K404 UPS4616-5BNAS1

TECHNICAL BULLETIN

13 DEC 2016

Update Prior to Sale: V6 Petrol Coolant Hose Chafe

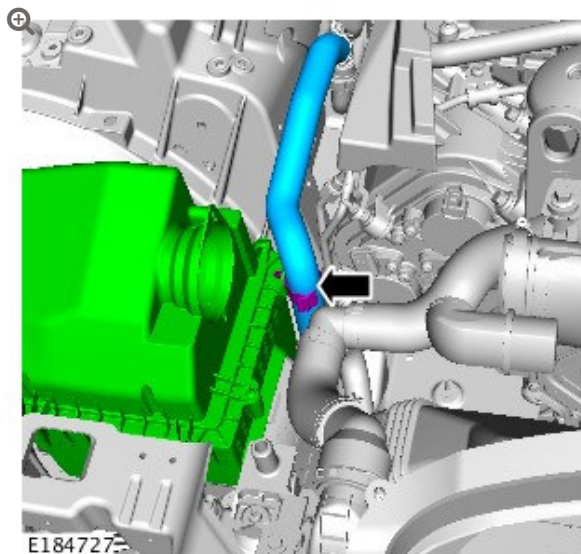
Check that the fir tree clip for the coolant hose is installed and located and secure on the right-hand air cleaner.

- If the fir tree clip for the coolant hose is installed on the right-hand air cleaner and securely attached to the coolant hose, release the vehicle.
 - No further action required.
- If the fir tree clip for the coolant hose is installed on the right-hand air cleaner and not securely attached to the coolant hose, check the coolant hose for damage.
 - If the coolant hose is not damaged, latch the coolant hose into the fir tree clip, and release the vehicle.
 - No further action required.
 - If the coolant hose is damaged, continue to Step 3.

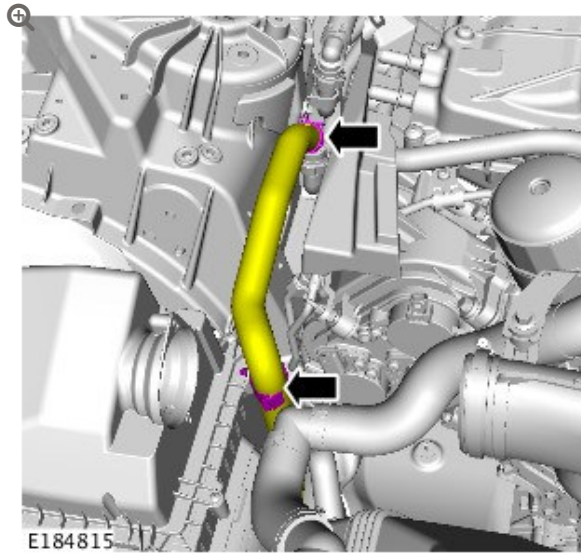
Release the coolant hose retaining clips and position to one side.

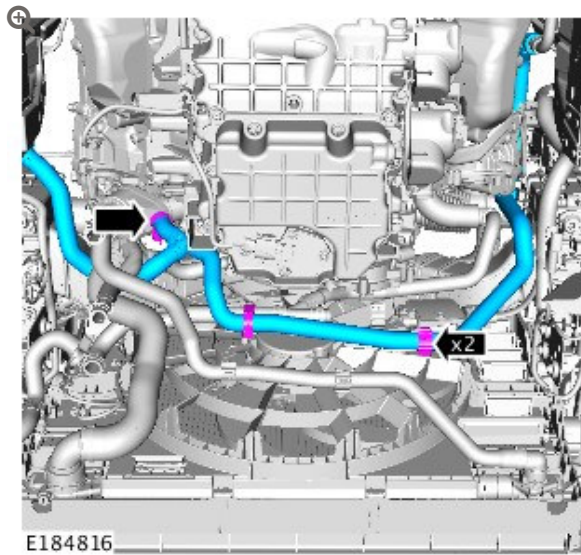
Release the coolant hose retaining clips.

- 1 Release the coolant hose.
- 7 Reverse the removal procedure to install the new coolant hose.
